CITY OF DALLAS
LANDMARK COMMISSION
Monday, January, 2020
AGENDA

Monday, January 6, 2020

J. L. LONG MIDDLE SCHOOL - FLOOR PLAN - LEVEL 01

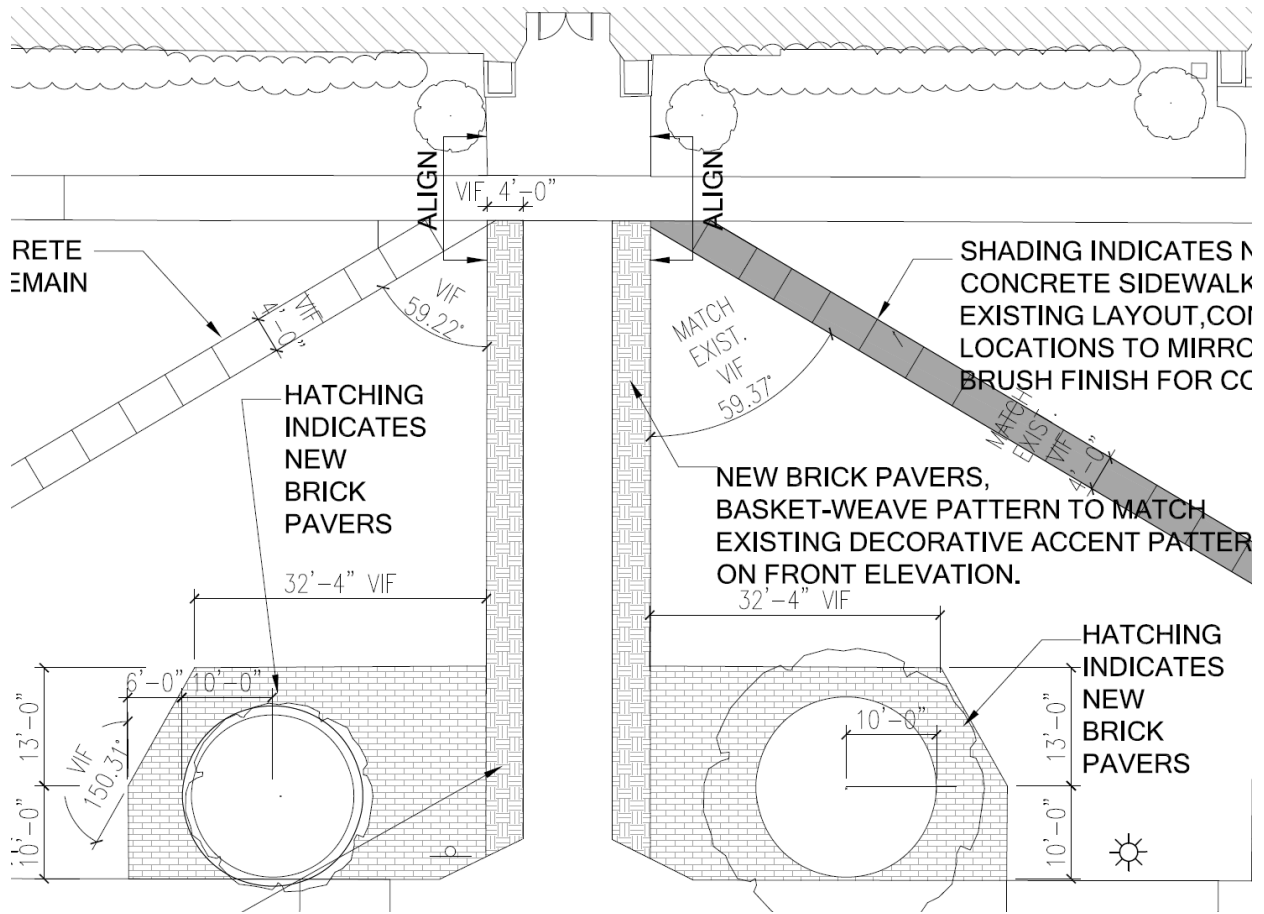
Install new hardscaping at front elevation – Deny without Prejudice - Deny without prejudice due to lack of information. Clarify what the substrate/foundation for brick pavers will be; Provide sample of brick pavers; Recommend using hard fired brick and not concrete bricks; Clarify brick pattern and brick color; Recommend brush finish concrete in similar tone to existing for new concrete

walkways; Show control joints for new concrete walkways on site plan; Show existing benches on site plan; Clarify if any irrigation systems will be installed as part of this work.

- Clarify what the substrate/foundation for brick pavers will be.
- Provide sample of brick pavers
- Recommend using hard fired brick and not concrete bricks
- Clarify brick pattern and brick color
- Recommends brush finish concrete in similar tone to existing for new concrete walkways
- Show control joints for new concrete walkways on site plan.
- Show existing benches on site plan.

- The applicant did not include the benches on the revised drawing, but indicated that they would not be moved from their current locations.
- Installation of an irrigation system was not a part of this application and is not required. Installation of irrigation systems do not typically require a CA.

- NOTES 12-19-19
1. Existing benches to remain in place
 2. Brush finish for new concrete sidewalk to match existing sidewalk.
 3. Basketweave pattern for decorative brick paver band flanking front walk, edge aligned with existing buttresses flanking front entrance.
 4. Substrate for brick pavers to be dft.

North and East elevations for pergola and addition

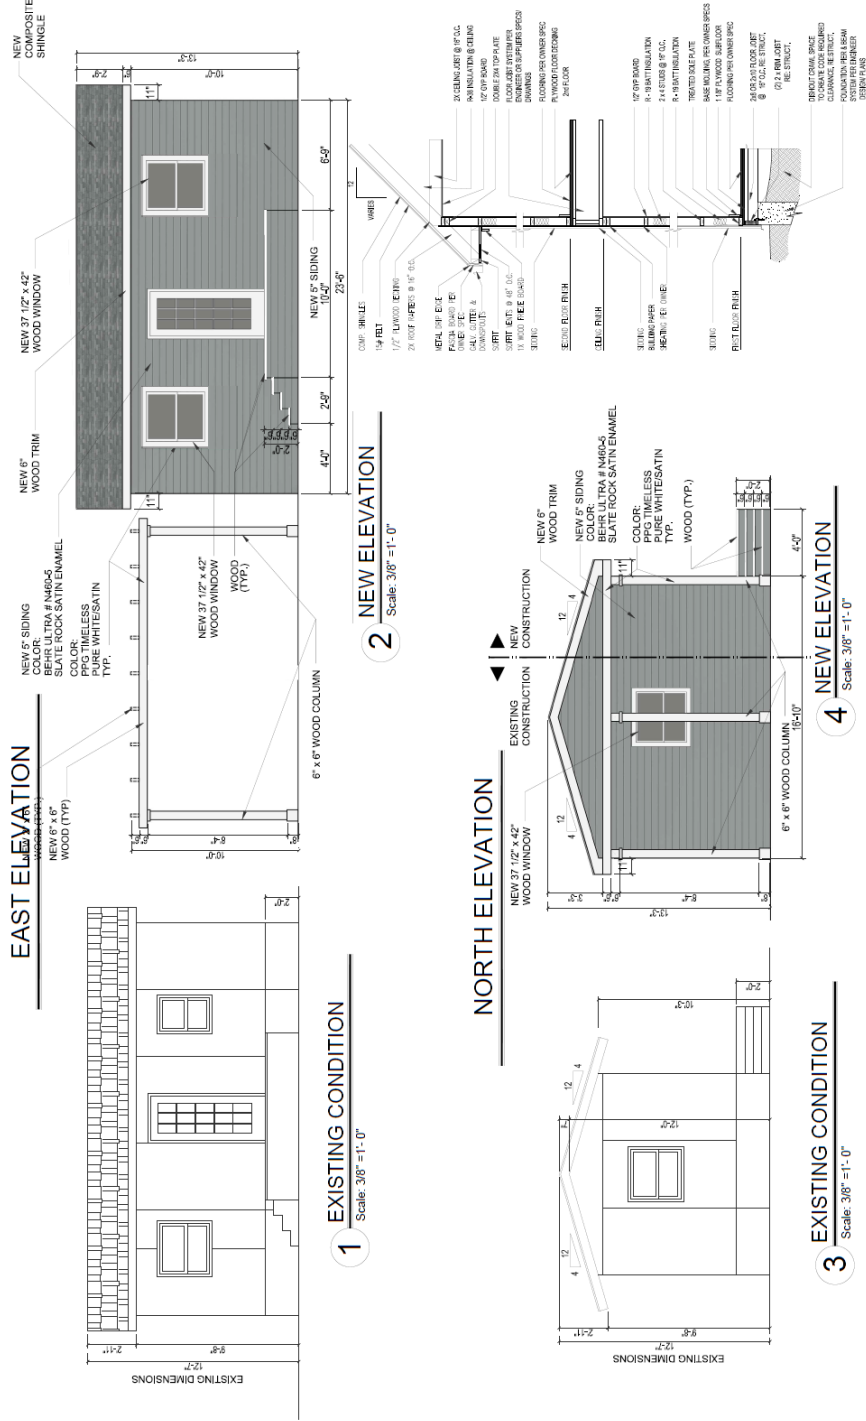
1. Replace all existing siding on main and accessory structures with new #117 wood siding - No quorum, comments only - Indicate photo/labels of siding proposed on elevations of main structure.
2. Construct pergola style carport in rear yard - No quorum, comments only - Provide material labels/dimensions for pergola columns.
3. Construct addition on rear accessory structure - No quorum, comments only - Provide cut sheets on windows & door with dimensions for accessory structure. Provide accurate stoop elevation on accessory structure. Accessory structure roof overhang dimensions & eave trim labels to be provided.

- 1) Replace all existing siding on main and accessory structures with new #117 wood siding. - No quorum, comments only - Indicate photo/labels of siding proposed on elevations of main structure.
- 2) Construct pergola style carport in rear yard. - No quorum, comments only - Provide material labels/dimensions for pergola columns.
- 3) Construct addition on rear accessory structure. - No quorum, comments only - Provide cut sheets on windows & door with dimensions for accessory structure.

Provide accurate stoop elevation on accessory structure. Accessory structure roof overhang dimensions & eave trim labels to be provided.

PROVIDE CUT SHEETS ON WINDOWS & DOOR W/ DIMENSIONS FOR
ACCESSORY STRUCTURE. PROVIDE ACCURATE STUOP ELEVATION
ON ACC. STRUCT. INDICATE PHOTO / LABELS OF SIDING PROPOSED ON
ELEVATIONS OF MAIN STRUCTURE. PROVIDE MATERIAL LABELS / DIMENSIONS
FOR PERGOLA COLUMNS, ACC STRUCT. ROOF OVERHANG DIMS. & EAVE TRIM
LABELS TO BE PROVIDED.

Request #2: Staff is recommending approval of construction of a new pergola in the rear yard. The pergola will be in the rear yard, not visible from the public right-of-way, and is similar in design to several pergolas. Task Force is supportive of the design, and asked that more dimension details be added to the plans, which the applicant has since provided.

Request #2 – Elevation and text demonstrating proposed window alteration.

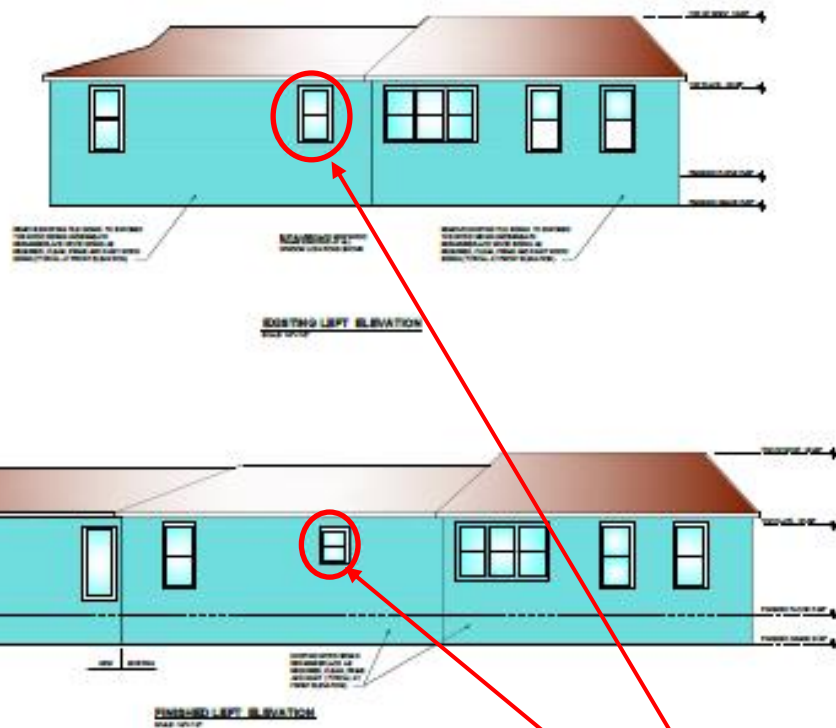
Request #2 – The applicant is requesting the alteration of a single window on the cornerside elevation to accommodate the kitchen floorplan that includes a shorter window over a kitchen counter. Staff is recommending denial without prejudice based on the preservation criteria that stipulates historic openings be maintained. Nevertheless, Staff does not believe that relocating and resizing the window would have an adverse impact on the historic structure, nor the historic overlay district. The number of windows on the elevation would not be altered, the window material and style would be appropriate, and the ratio between voids and spaces would not change in a significant way. Should Landmark decide to approve request #2, Staff would like to ensure that the window is one-over-one and made of wood to maintain historic integrity. Task Force also debated whether or not the proposed alteration would be an adverse impact, and concluded that it would not. Thus, Task Force was supportive of relocating and resizing the one window.

Proposed North (Front) & South (Rear) Elevations

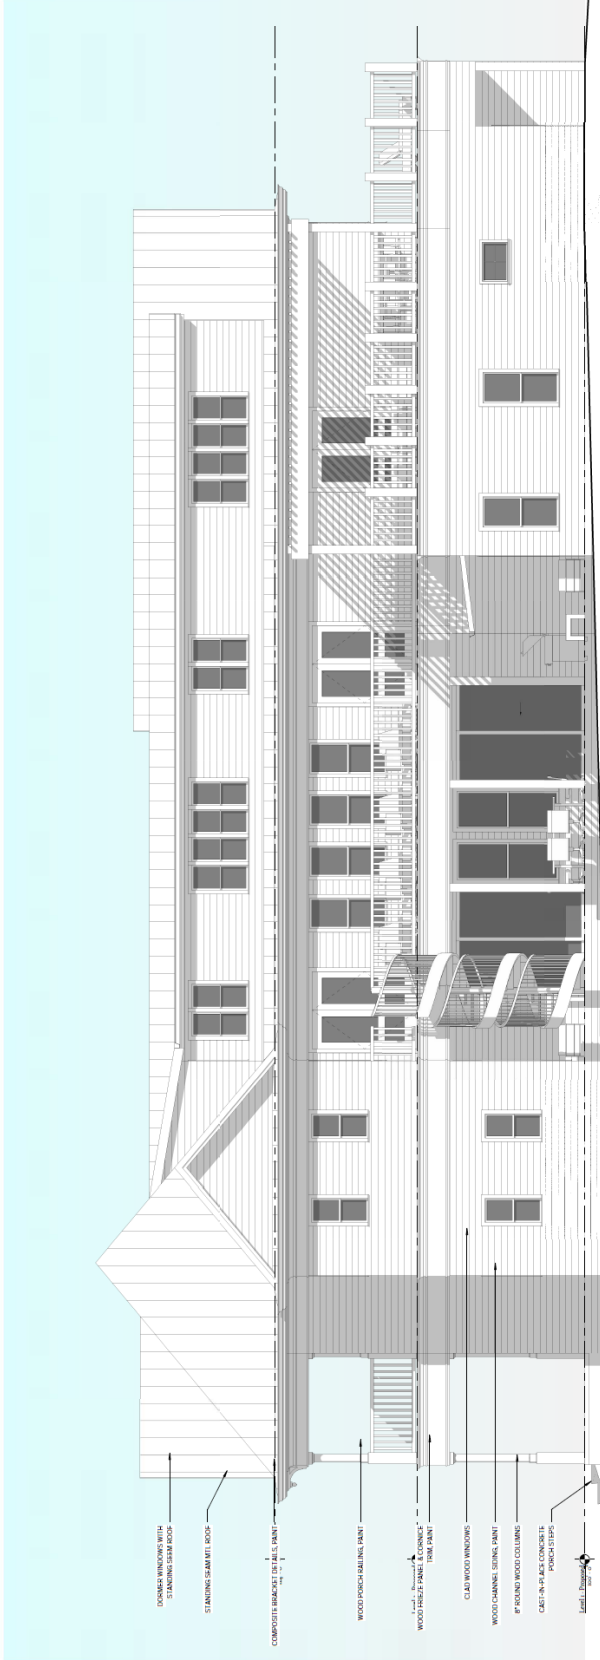
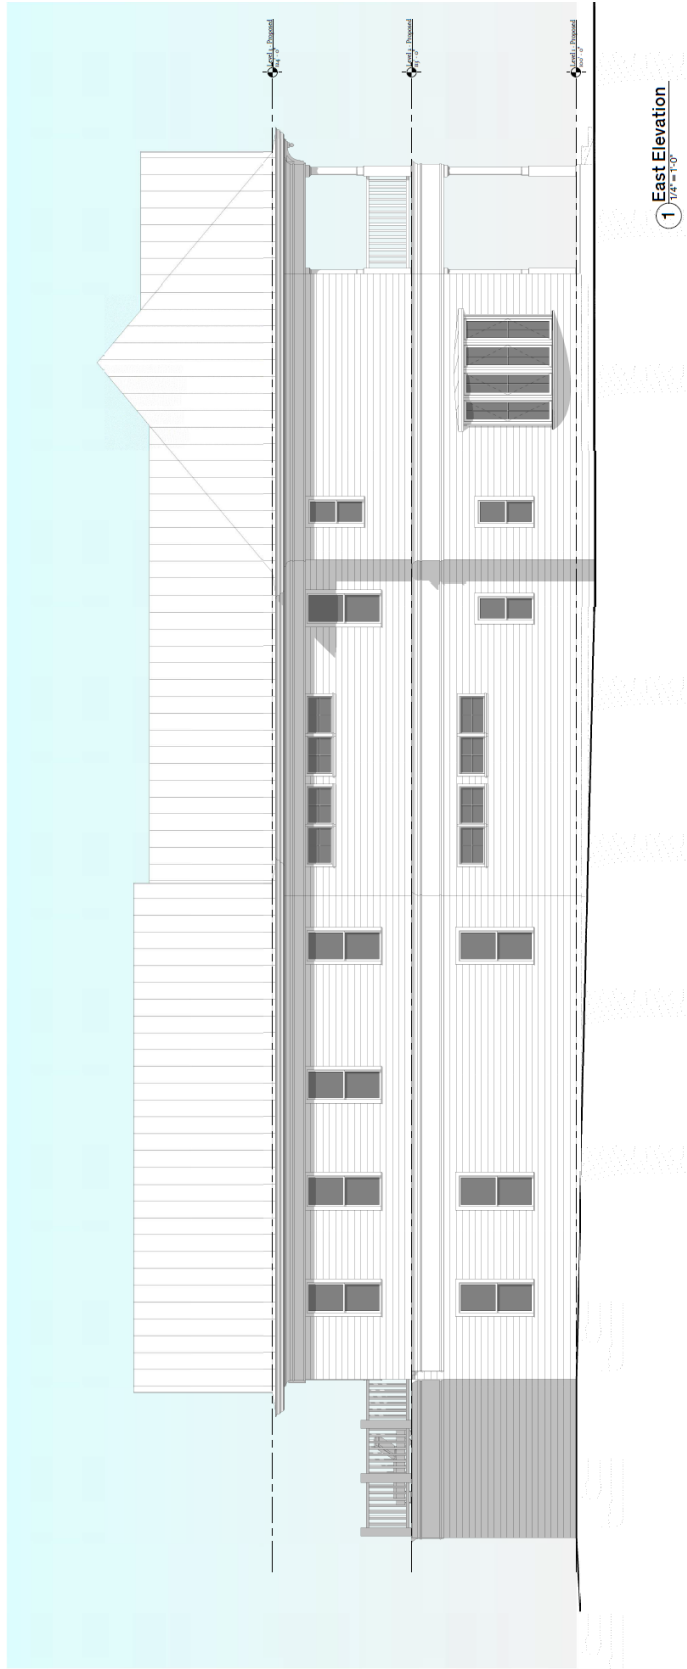
Construct a 2.5-story residence with attached garage – Approve with conditions – Approve with the condition that at least two French door openings on the front elevation be changed to double hung windows, that windows be added to the second floor above the bay window on the east elevation, and that the applicant return with a CA application for paint, roof color, landscaping, and fencing, with the finding the proposed work is consistent with preservation criteria section 51P-225.109(a)(3) for architectural detail; 51P-225.109(a)(5), (6), and (7)(A)(i) for building eaves, placement and widths; section 51P-225.109(a)(10) for columns; section 51P-225.109(a)(11) for façade materials; section 51P-225.109(a)(12)(A)(i), (B), (D), and (F) for front entrances and porches; section 51P-225.109(a)(14)(A), (B), (C), and (E) for roof forms; section 51P-225.109(a)(16)(A)(i), (B), (F) for windows and doors; and meets the standards in City Code Section 51A-4.501(G)(6)(c)(i).

Construct a 2.5-story residence with attached garage – Approve with conditions - Roof material to be typical to the district; less door openings on front with more harmony between ground and second floors; add windows to east facade second floor above bay; front door to be wood; provide window samples for clad windows and other clad doors.

Staff agrees with the Task Force recommendation to reduce the number of French door openings on the front elevation. This number of door openings (five) is not typical of Folk Victorian Style structures in general, and is not typical of the historic Victorian residences in the district. Staff also agrees with their recommendation to add a window (or windows) to the second floor above the bay window on the east elevation.

ROOF MATERIAL TO BE TYPICAL TO THE DISTRICT
LESS DOOR OPENING ON FRONT W/ MORE VARIATION BETWEEN FLOORS
ADD WINDOWS TO EAST FACADE 2nd FLOOR ABOVE BAY
PROVIDE WINDOW SAMPLES FOR CLAD WINDOWS + OTHER DOORS
FRONT DOOR TO BE WOOD

- In response to the Task Force comments from December, the applicant eliminated the contemporary style square fixed windows from the side elevations.
- Applicant clarified that the windows would be aluminum clad, double hung, wood windows from the Pella Architect Series Reserve.
